METROPOLITAN GOVERNMENT OF NASHVILLE AND DAVIDSON COUNTY

STAFF RECOMMENDATION
1712 Blair Boulevard
December 16, 2020

Application: New Construction—Addition; Partial Demolition
District: Belmont-Hillsboro Neighborhood Conservation Zoning Overlay
Council District: 18
Base Zoning: RM20
Map and Parcel Number: 10416004300
Applicant: Will Jenner
Project Lead: Melissa Sajid, melissa.sajid@nashville.gov

Figures 2 and 3. Two-story enclosed porch to be demolished and 1914 Sanborn map.

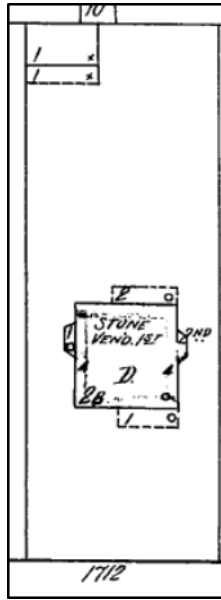
Partial Demolition: The applicant proposes to demolish an existing two-story enclosed porch located at the rear of the historic house (Figure 2). The 1914 Sanborn map shows a two-story covered porch in the same location (Figure 3). While the porch may be original to the house, staff finds that its demolition can be appropriate. Given the porch's location at the rear of the house along with its separate roof form and change in materials, staff finds that this element is not a character defining feature of the historic house and that its demolition would meet Section V.2 for appropriate demolition and would not meet Section V.1 for inappropriate demolition.

1 LEFT ELEVATION
1/4" = 1'-0"

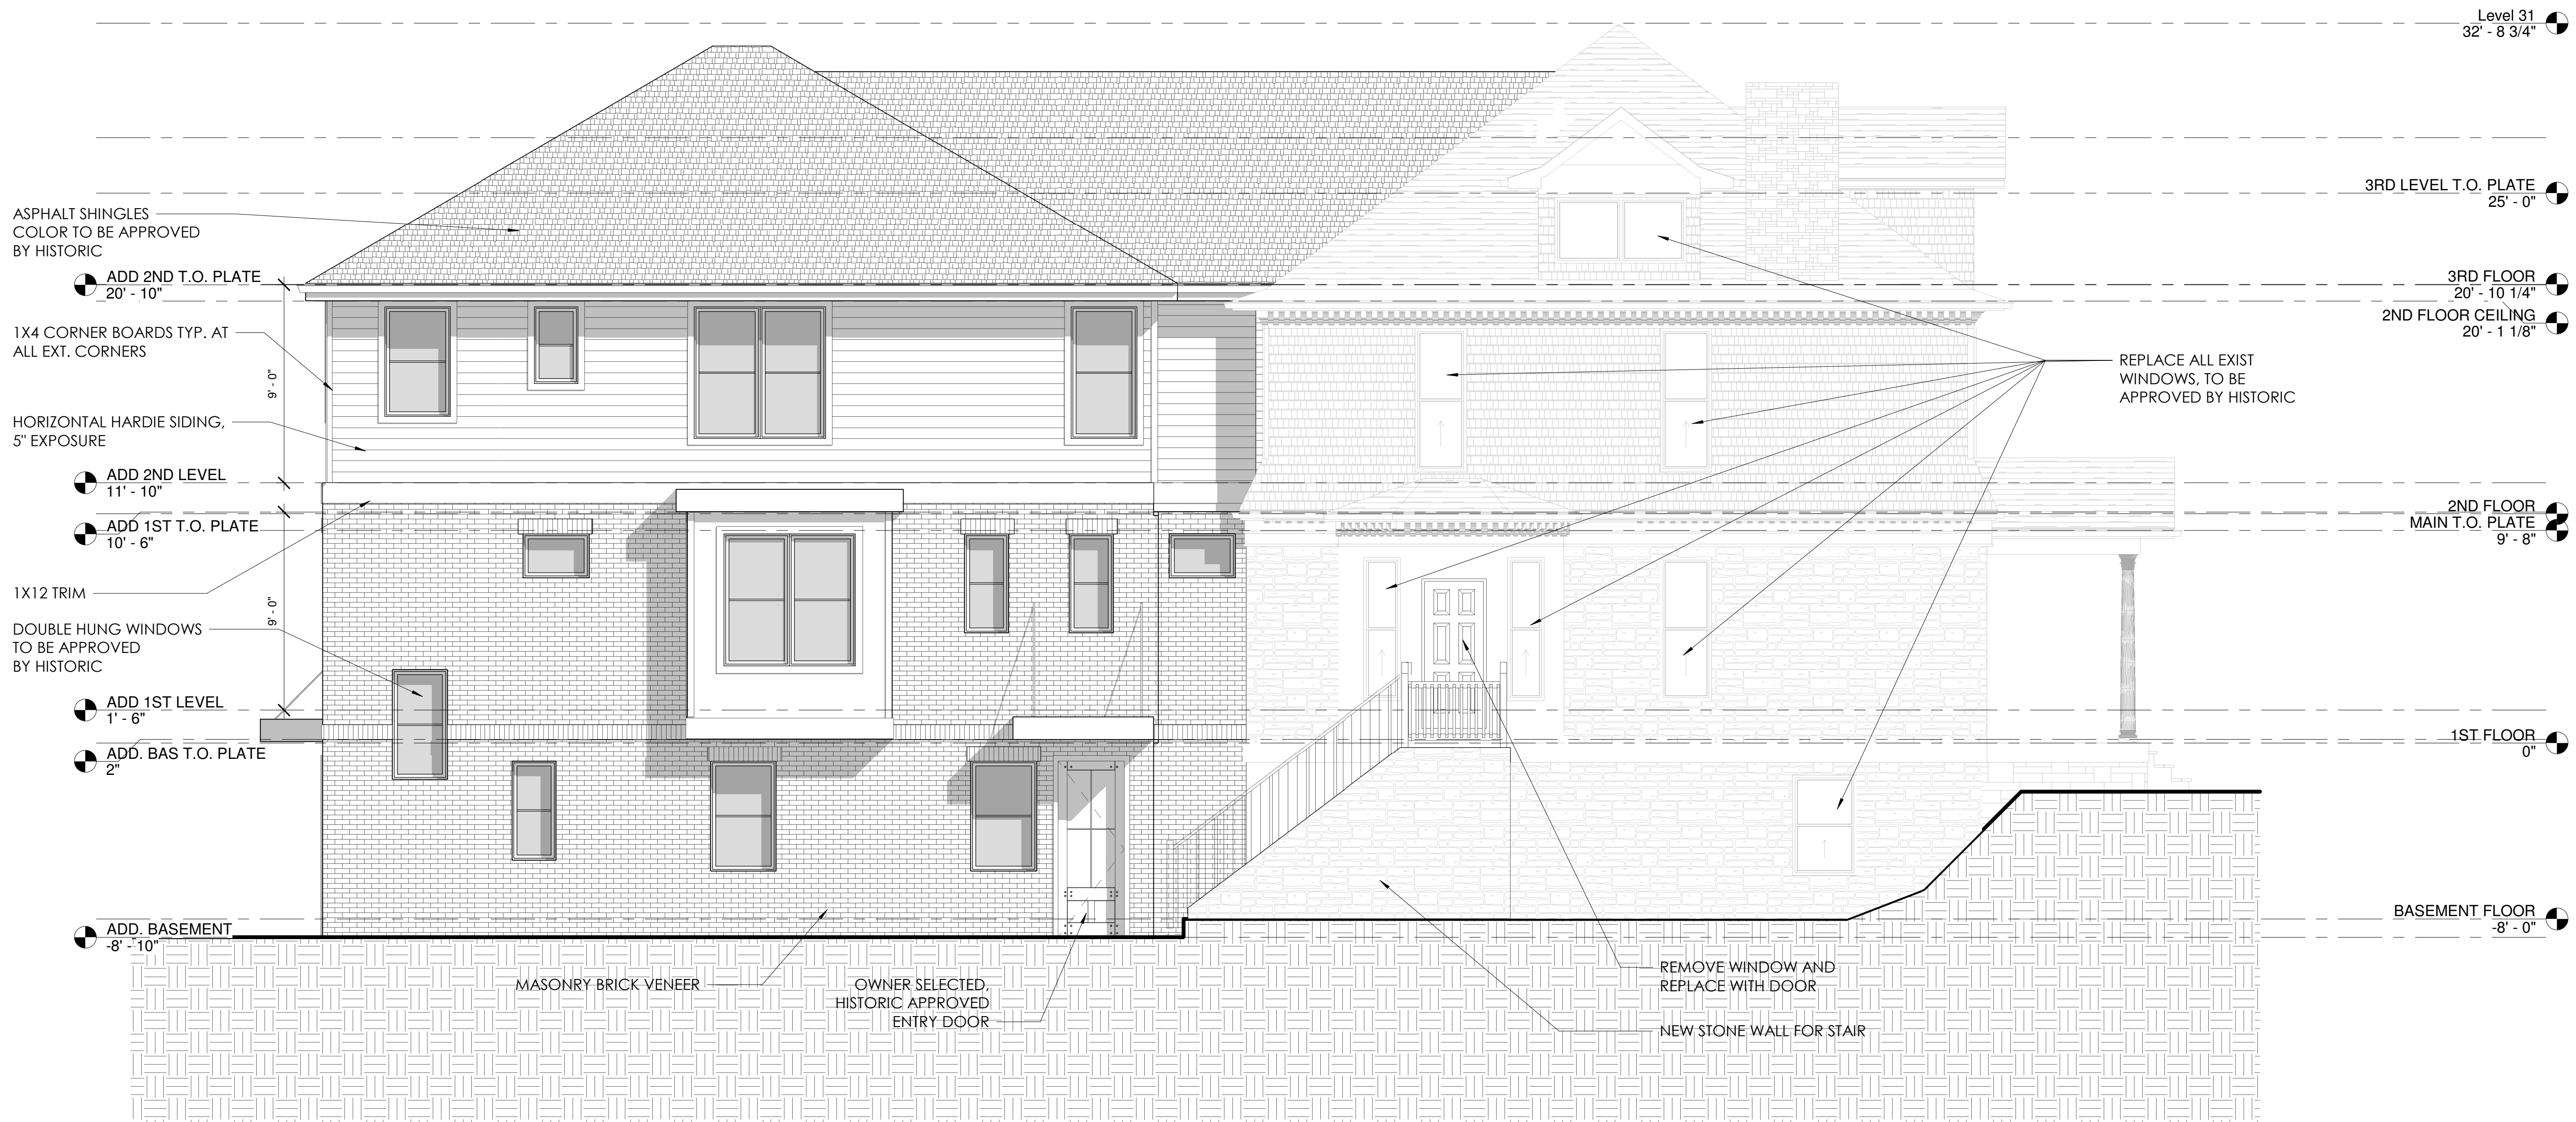
While the exterior stair is to be removed from the right-side façade, a new exterior stair is to be added to the left-side and a window converted to a door to access a dwelling unit (Figures 5 and 6). The proposed alterations are at the location of a bay window that was present as early as 1914 (Figure 3) but has been altered so that only the roof of the bay window remains.

Converting a window to a door or even adding a door beyond the midpoint on a side façade might be appropriate if the door is located at the ground level. However, the location of the proposed door necessitates the addition of new exterior stairs. The existing exterior stairs on the right-side pre-date the overlay, so they could remain or be removed as proposed. Staff finds that introducing a new exterior staircase on a side elevation where they did not exist historically is inappropriate given the visibility of the addition. Some alternatives that would meet the design guidelines would be to introduce a door opening at the basement-level or to add an exterior stair to the rear of the addition.

Proportion and Rhythm of Openings: Most of the windows on the proposed addition are generally twice as tall as they are wide, thereby meeting the historic proportions of openings. The plan proposes two small horizontal windows on the left side of the addition; one is located in the alcove between the historic house and new addition, and the other is located beyond the proposed bay window, closer to the rear. Staff finds that the proposed horizontal windows can be appropriate in these locations since they are not likely to be visible from the street. There are no large expanses of wall space without a window or door opening. Staff finds the project's proportion and rhythm of openings to meet Section II.B.1.g.

With the condition that the window opening on the left-side façade of the historic house not be converted to a door with associated stairs, staff finds that the proposed partial demolition can meet Section V.2 for appropriate demolition and does not meet Section V.1 for inappropriate demolition.
